CITY OF LOS ANGELES
DEPARTMENT OF PUBLIC WORKS
Bureau of Engineering
GEOTECHNICAL ENGINEERING DIVISION

ENGINEER OF RECORD – BOYLE HEIGHTS SPORTS CENTER PROJECT
933 S MOTT STREET AND 2510 E WHITTIER BLVD, LOS ANGELES
TRACT: M.L. WICKS' STEPHENSON AVENUE TRACT NO. 2, BLOCK: --, LOT: 12 &
TRACT: TR 5299, BLOCK: --, LOT: 21
W.O. E170192B **GED FILE NO. 17-086**

Reference: Willdan Geotechnical "Geotechnical Investigation Report, Proposed Boyle Heights Sports Center Project, 933 South Mott Street, Los Angeles, California" dated October 17, 2017.

Figure **1**

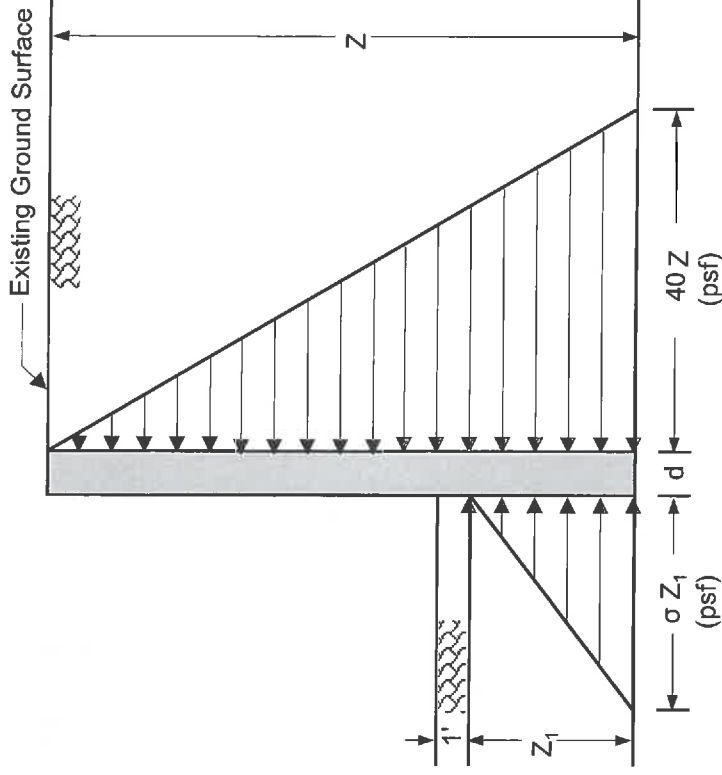
Cantilever or braced shoring shall be designed for the lateral earth pressures shown on Figure 1. These values are based on the assumption that (1) the shored soil material is level at ground surface, (2) the exposed height of the shoring is no greater than 15 feet, and (3) the shoring is temporary, and will not be required to support the soil longer than about six months. Surcharge coefficients of 0.30 and 0.50 may be used with uniform vertical surcharges for cantilever and braced shoring lateral earth pressures, respectively. These surcharge pressures should be added to the lateral earth pressures.

$\sigma = 240$ pcf for soldier piles spaced at least $3d$ apart applied over $2d$
 $\sigma = 240$ pcf for soldier piles spaced less than $3d$ apart
 The maximum passive pressure shall not exceed $2,400$ psf.

Figure
No. 2

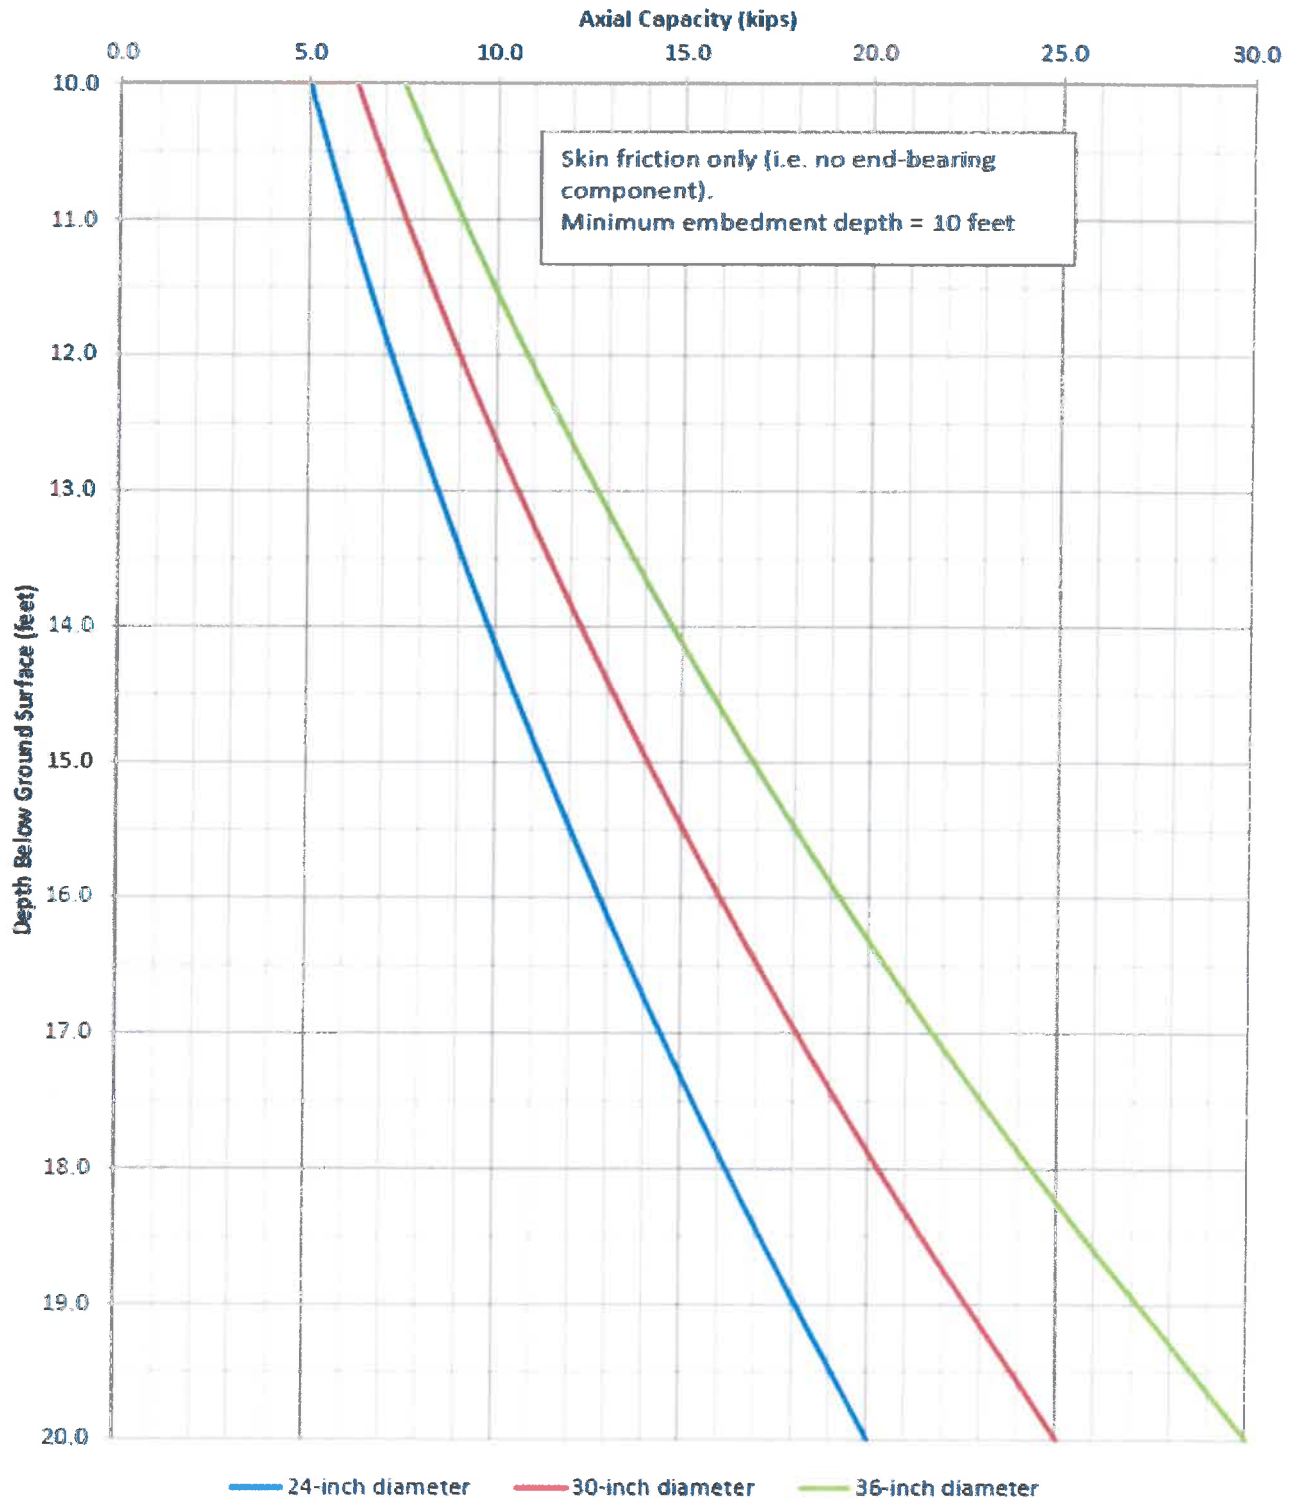
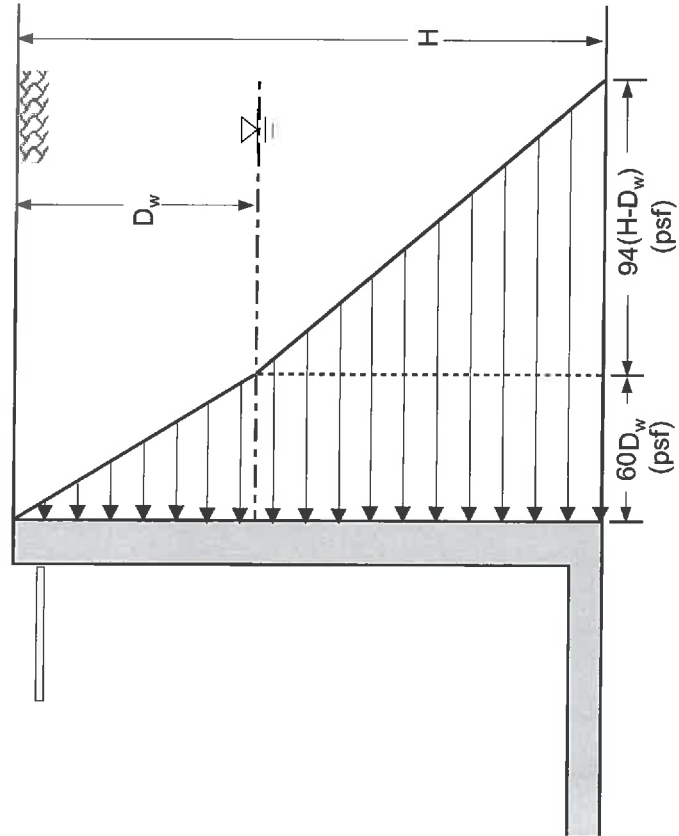
Axial compression capacities are presented on Figure 2 for 24-inch, 30-inch, and 36-inch diameter CIDH piles. The minimum pile embedment depth shall be 10 feet below the lowest adjacent grade. The actual depths may be deeper and will likely depend on the required lateral and tensile loads. We anticipate the piles will be isolated (i.e. spaced at least 3 pile diameters on center), and therefore, group effects are not anticipated.

The axial compression capacities presented on Figure 2 assume the CIDH piles develop their capacity solely from side resistance (i.e. skin friction).

The allowable axial tensile capacity may be assumed to be $\frac{1}{2}$ the axial capacity in compression for the 24-inch, 30-inch and 36-inch diameter CIDH piles (Figure 2). The weight of the concrete shaft may be added to the tensile capacity.

3

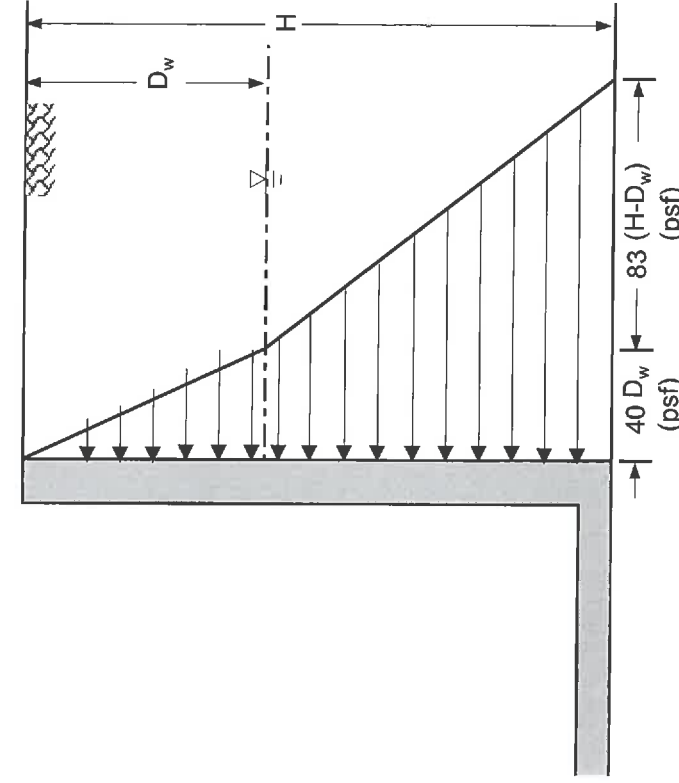
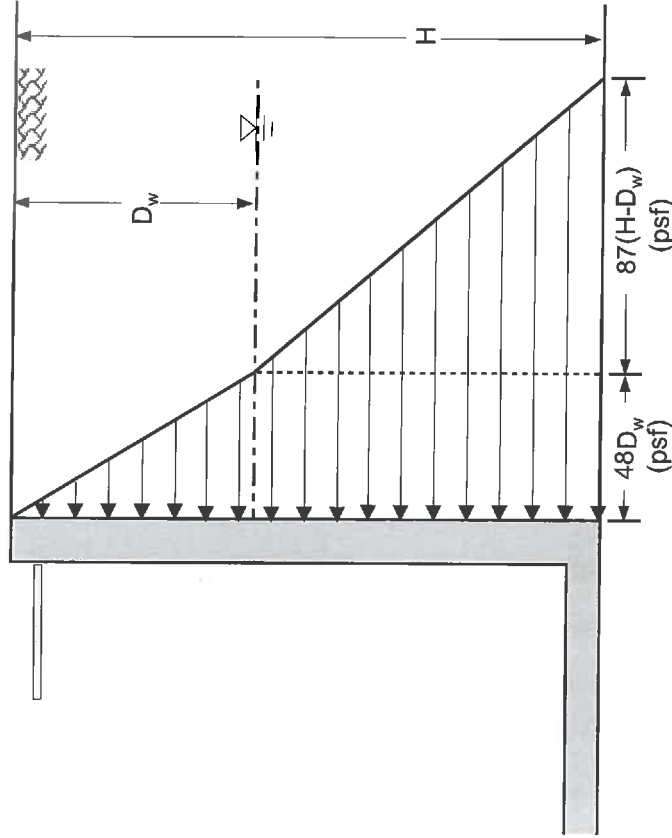
The design lateral earth pressures for permanent retaining structures are presented on Figure 3 in this letter. The design lateral earth pressures for gravel-sand mixtures are presented on Figure 4 in this letter. The lateral earth pressures presented on Figure 4 may only be used instead of those on Figure 3 if the entire theoretical failure wedge is backfilled using select sand-gravel material. The lateral earth pressures shown on Figures 3 and 4 are applicable for backfill inclinations no steeper than 5:1 (horizontal:vertical).

For basement (i.e. restrained) walls, a seismically induced pressure increment of 10 pounds per cubic foot (pcf) may be used instead of 25 pcf. This reduced value of 10 pcf was estimated using the provisional recommendations by Lew et al. (2010) and the Mononobe-Okabe method.

If surcharge loads (live or dead) are applied, they should be added to the active or at-rest earth pressure by applying a uniform (rectangular) pressure. The lateral earth pressure coefficient for a uniform vertical surcharge is 0.33 and 0.50 for an active and at-rest condition, respectively.
